Access Compliance Report

Public Rights-of-Way

(Curb Ramps)

Intersection ID: 12194	Main Street: S_CEDAR_ST	Cross Street: W_HILL_ST	Location: S
ADA ID: 8B7CB107D42D	Ramp Type: PerpDiag	Initial Pass/Fail: Pass	Overall Compliance: No
Severity Score: 2.75			
Codes/Mitigation Info/Possible Solution		Field Measurements/Component Compliance

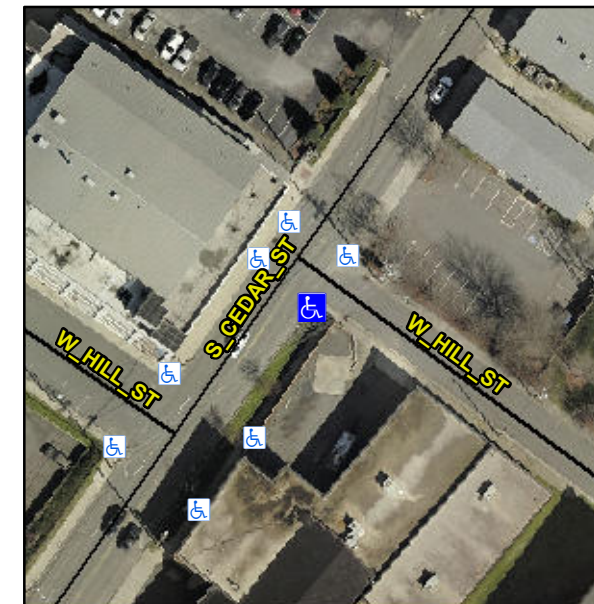
Not Found, R304.5.3, R304.2.2-Perp, R304.3.2-Para, R305.1.4, R305.2

Compliance	Description	Data	Compliance	Description	Data
N/A	Ramp Length (in)	62.0	Yes	Ramp Slope (%)	5.9
Yes	Ramp Width (in)	60.0	No	Ramp XSlope (%)	3.2
N/A	Flare Type LT	Sloped	N/A	Flare Type RT	N/A
N/A	Flare Slope LT (%)	8.5	Yes	Flare Slope RT (%)	0.7
N/A	Flare Traversable LT?	Yes	N/A	Flare Traversable RT?	Yes
Yes	Landing Length (in)	60.0	Yes	DWS Provided?	Yes
Yes	Landing Width (in)	60.0	Yes	DWS Contrast?	Yes
No	Landing Slope (%)	5.0	Yes	DWS Length (in)	24.0
No	Landing X Slope (%)	3.3	No	DWS Full Width?	No
N/A	Landing Curb? (Y/N)	No	No	DWS Offset (in)	4.5
N/A	Shared Landing?	Yes			
Yes	Gutter Ponding?	No	Yes	Gutter Slope (%)	1.7
Yes	Gutter Lip Ht (in)	0.0	No	Gutter X Slope (%)	2.5
N/A	Painted X Walk1?	No	N/A	Painted X Walk2?	No
	X Walk 1 Direction	To NE		X Walk 2 Direction	To NW
N/A	X Walk 1 Width (in)	N/A	N/A	X Walk 2 Width (in)	N/A
	X Walk 1 Slope (%)	3.6		X Walk 2 Slope (%)	5.2
	X Walk 1 X Slope (%)	2.1		X Walk 2 X Slope (%)	1.2

Remove & Replace Curb Ramp With Two New Directional Ramps or Equivalent. Remove & Replace Gutter.
